U.S. DEPARTMENT OF ENERGY
memorandum

SUBJECT: Additional Information Related to Meeting with NRC on Quality Assurance

10 QUALITY ASSURANCE PROGRAM

Figure 10.1 Technical program control: test plans and procedures (illustrative)

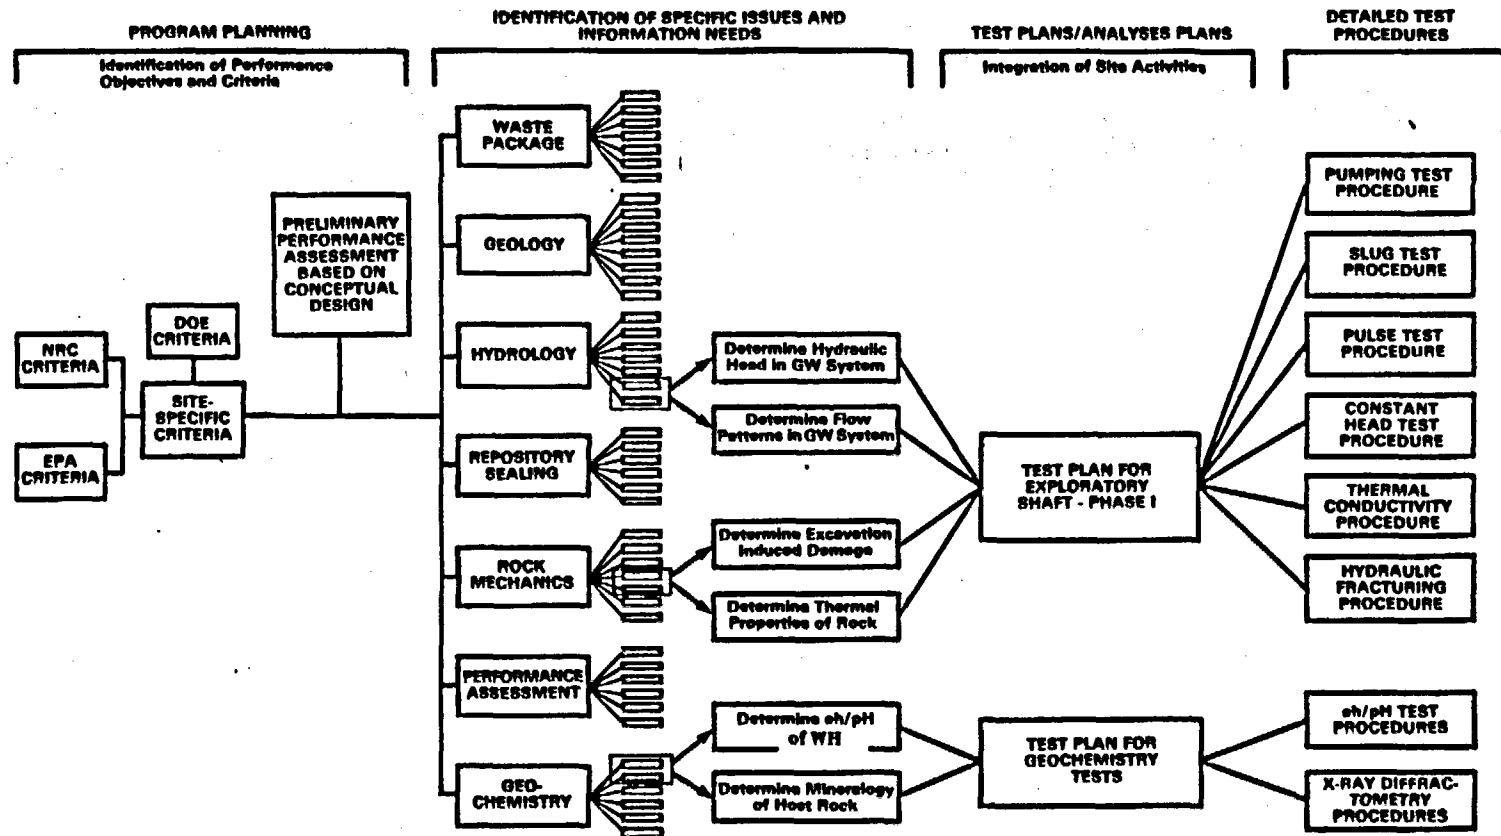
systematic approach to planning and controlling the program. The plans controlling the conduct of a data gathering program are of varying levels of detail. They should go from identification of general performance objectives and criteria to detailing specific technical procedures. Figure 10.1 illustrates this, and it is consistent with what the staff understands the BWIP planning structure to be. Quality assurance must be applied at all levels of the program.

As shown in Figure 10.1, site characterization planning must start by considering EPA and NRC criteria. After a site is selected for further investigation, specific issues are identified, based on regulatory criteria and preliminary evaluation of repository performance.

In reviewing the SCR, the staff generally found that test plans and test procedures were not provided or referenced (see Figure 10.1). The SCR stops at the "information needs" level. The information presented is very general and does not give the staff enough detail to provide comments on test plans. Some procedures have been examined in previous workshops with DOE, but the staff expected this information to be at least referenced in the SCR. The staff recognizes that not all test plans and procedures may be needed at this time. However, some test plans (e.g., exploratory shaft and waste package development testing) should be available for QA review. Each chapter of this Draft SCA includes comments on the level of detail of the plans provided and gives examples of deficiencies.

Figure 10.2 Test method development (illustrative)

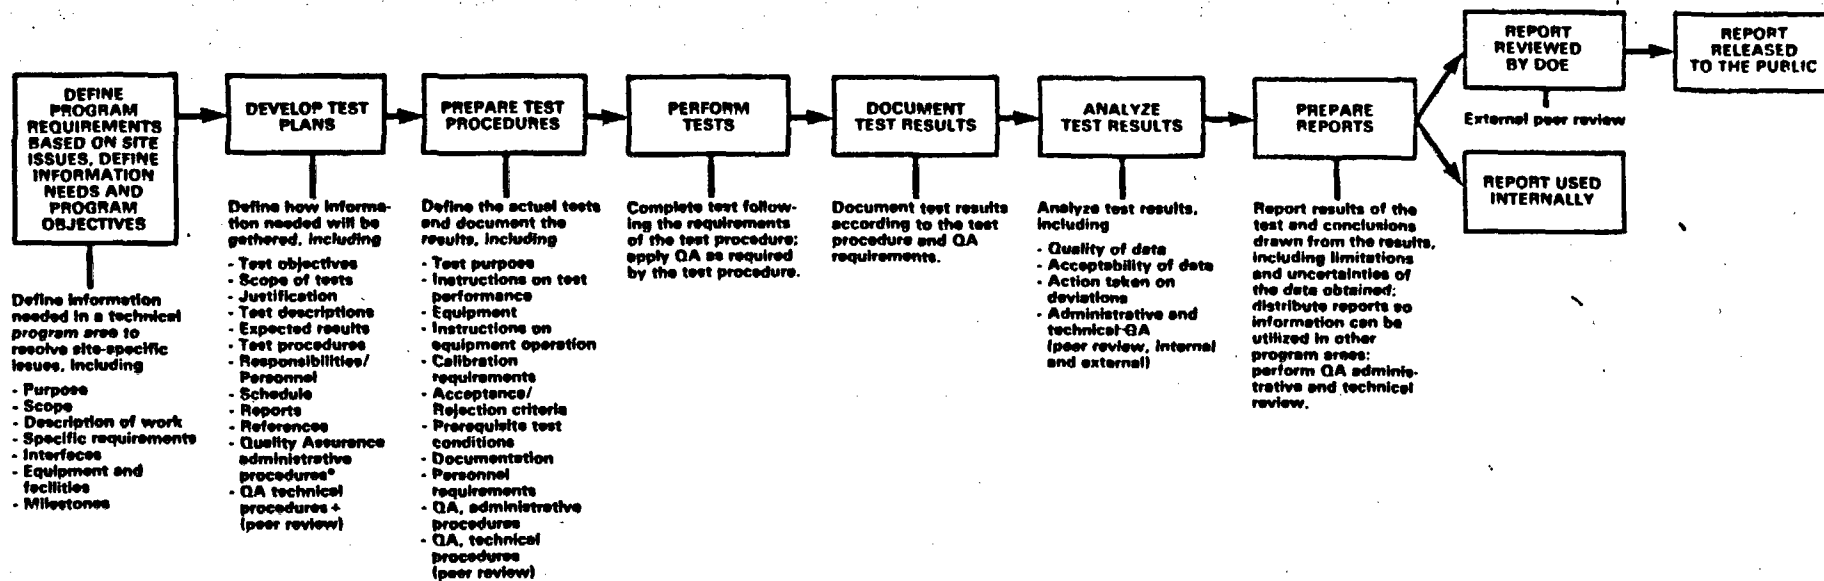
The development of the test plans and test methods is an important element in providing quality assurance for site characterization data. Figure 10.2 illustrates the development and chronology of events in planning and performing a testing program. This also shows the role of QA throughout the procedure, including how QA procedures incorporate reviews by (1) technical management and (2) peer review groups.

Figure 10.2 also illustrates the point where data should be documented (i.e., document test results) prior to analysis of test results. All data should be recorded under full QA requirements at this point in the test program. This data should be available to all interested parties (e.g., NRC, State programs, etc.) for inspection at an early date after it is documented.
